ADDENDUM NO. 2

NORTHWEST DEVELOPMENT AREA WATER AND SANITARY SEWER IMPROVEMENTS DAYTON INTERNATIONAL AIRPORT (10% MBE Participation)

ITEM NO. 1 – Bid Set Drawing Sheets

C2-7

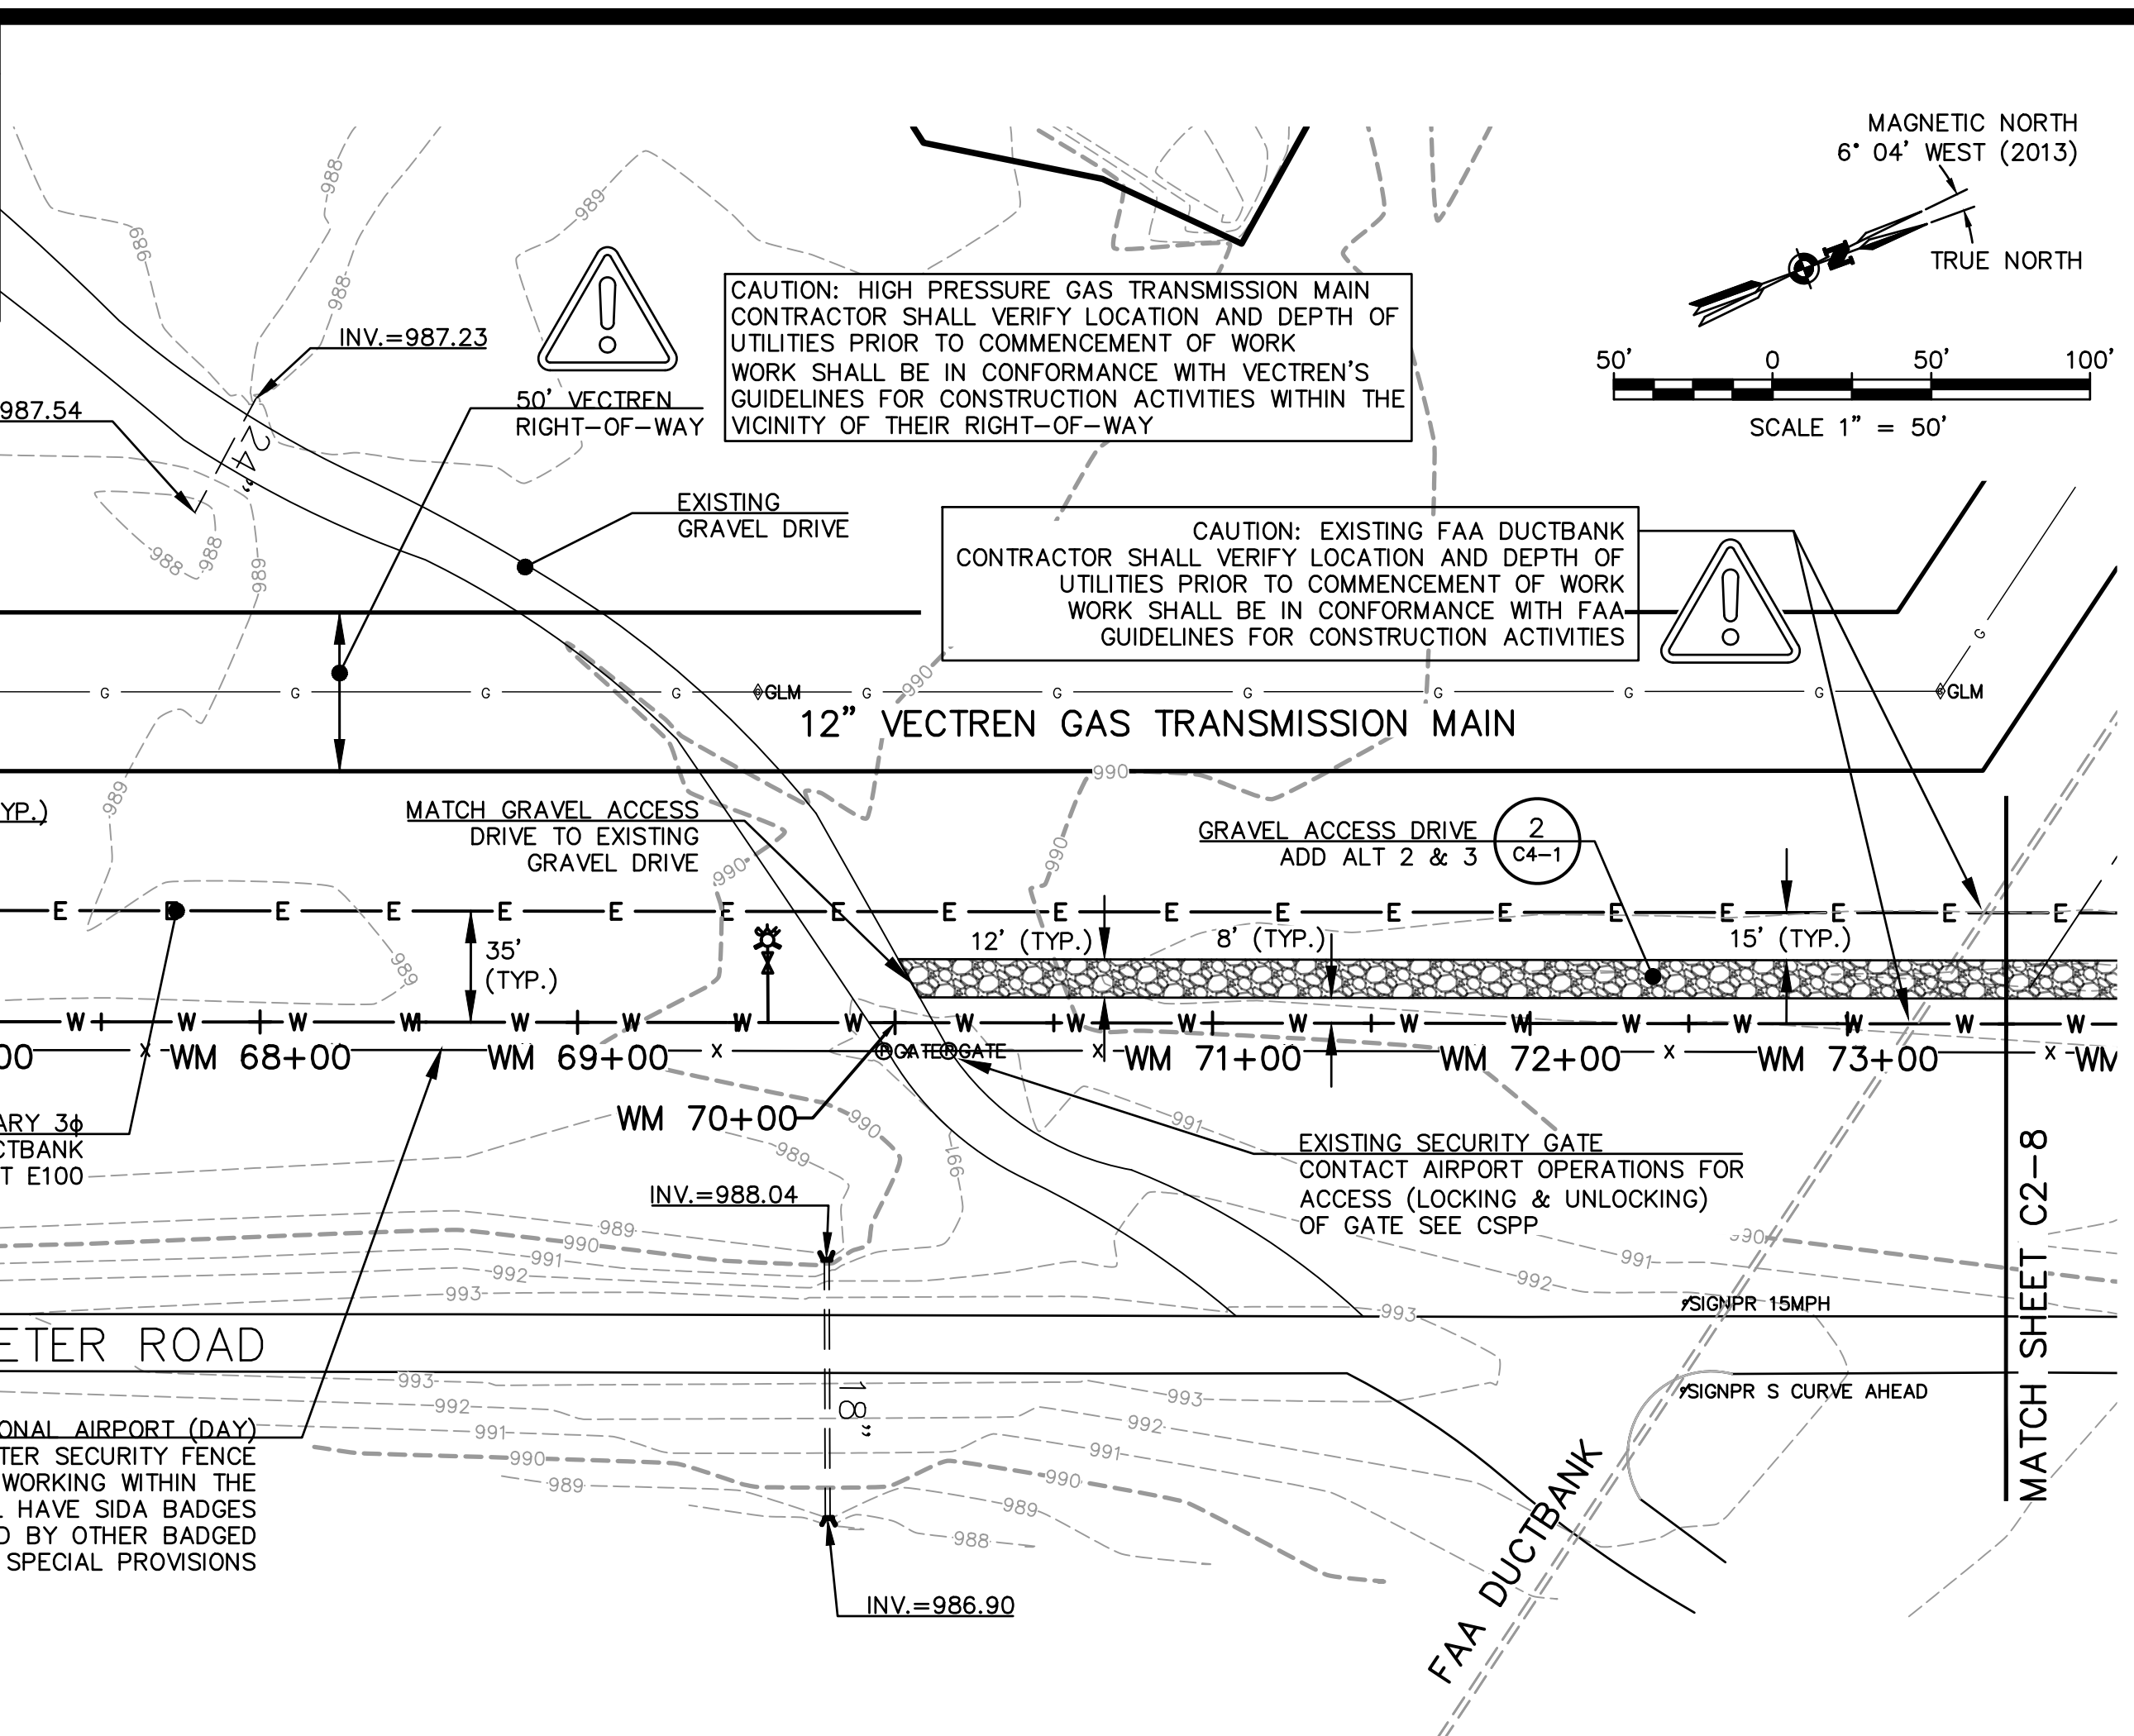
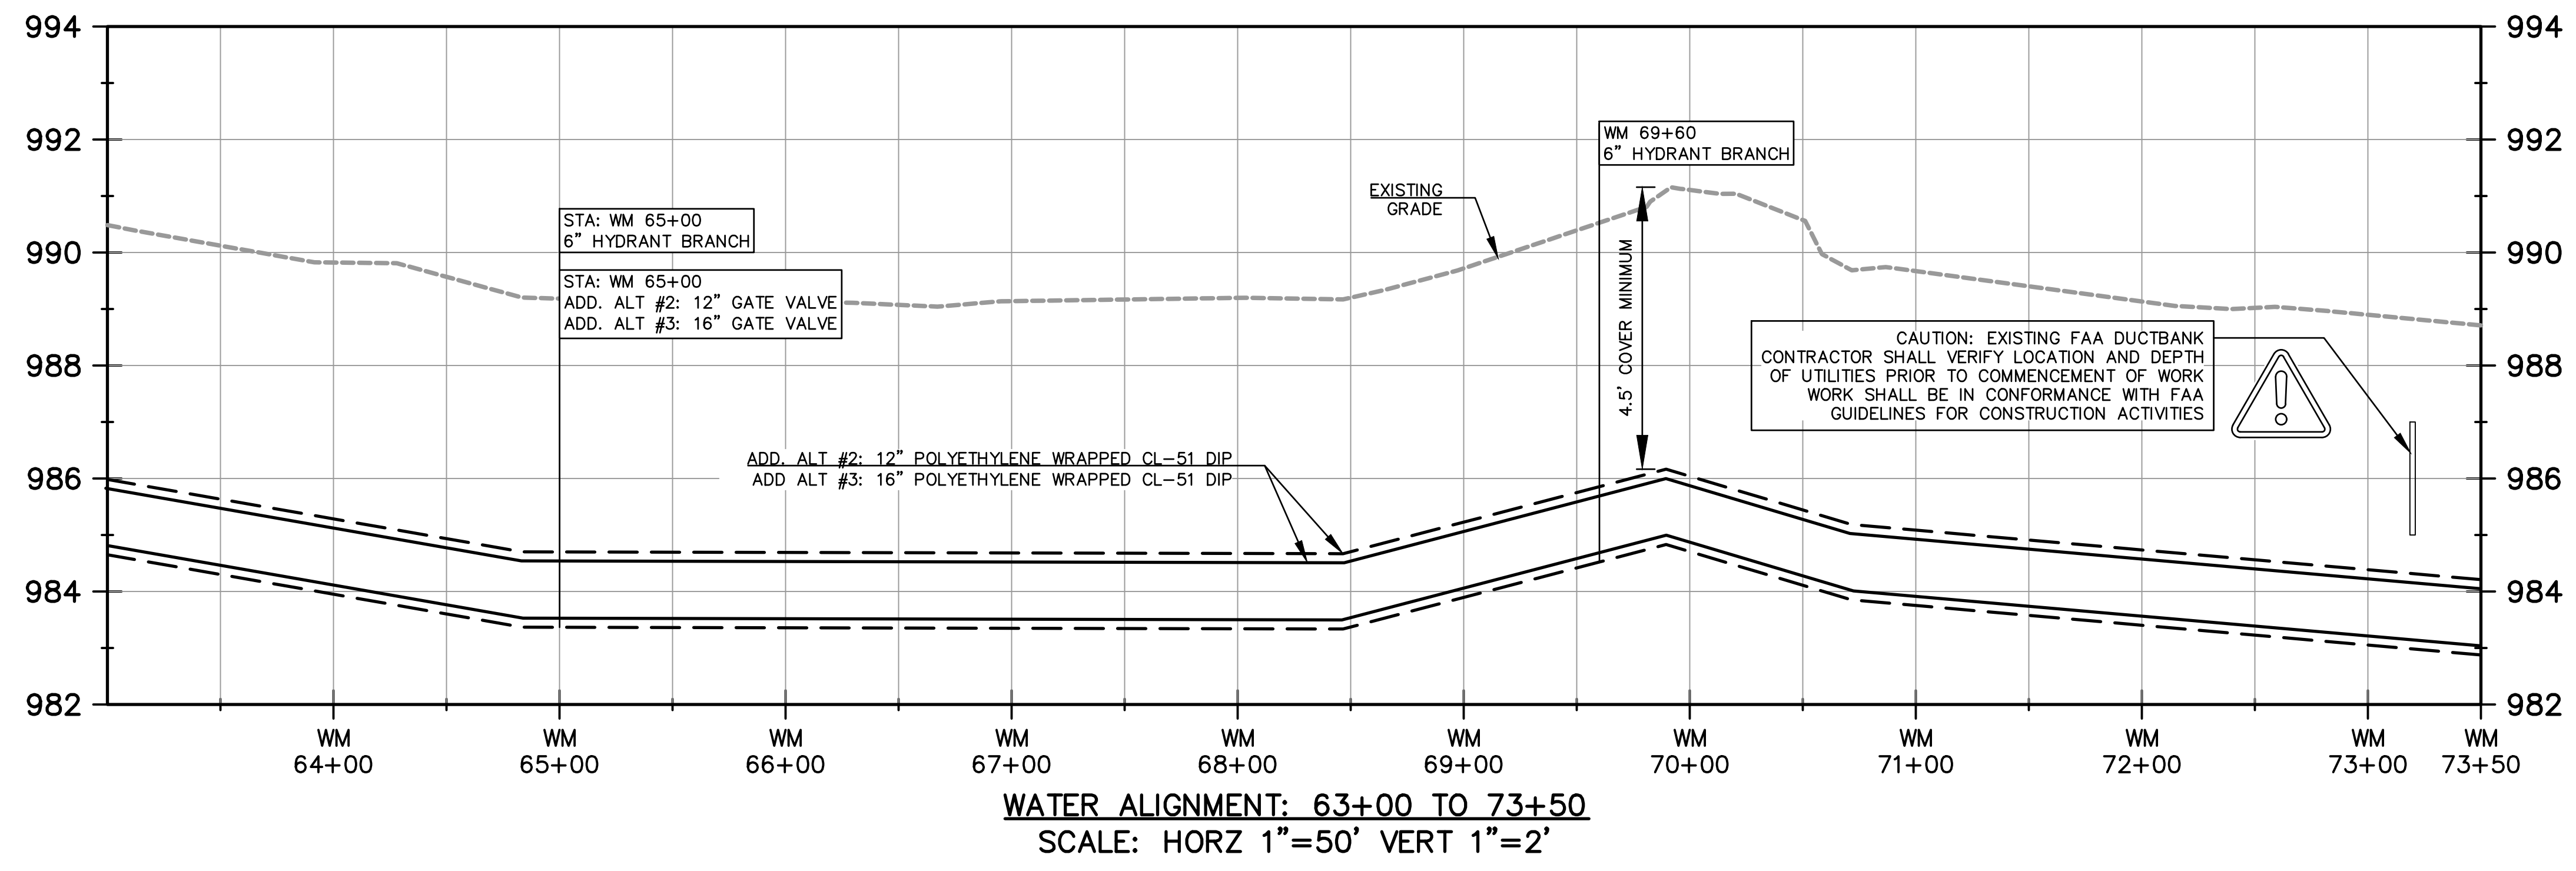
Clarification and Revise: Water main installation from Sta 55+50 to 82+69 is under Additive Alternate No. 4 on the Bid Proposal Form. Change all references from Add. Alt #2 to Add Alt. #4.

Clarification and Revise: Water main installation to upsize from 12" to 16" is from Sta 55+50 to 80+10, Meter Pit Start. The piping under Mill Creek to remain 12" ductile iron pipe. Change all references from Add. Alt #3 to Add Alt. #7 and #8.
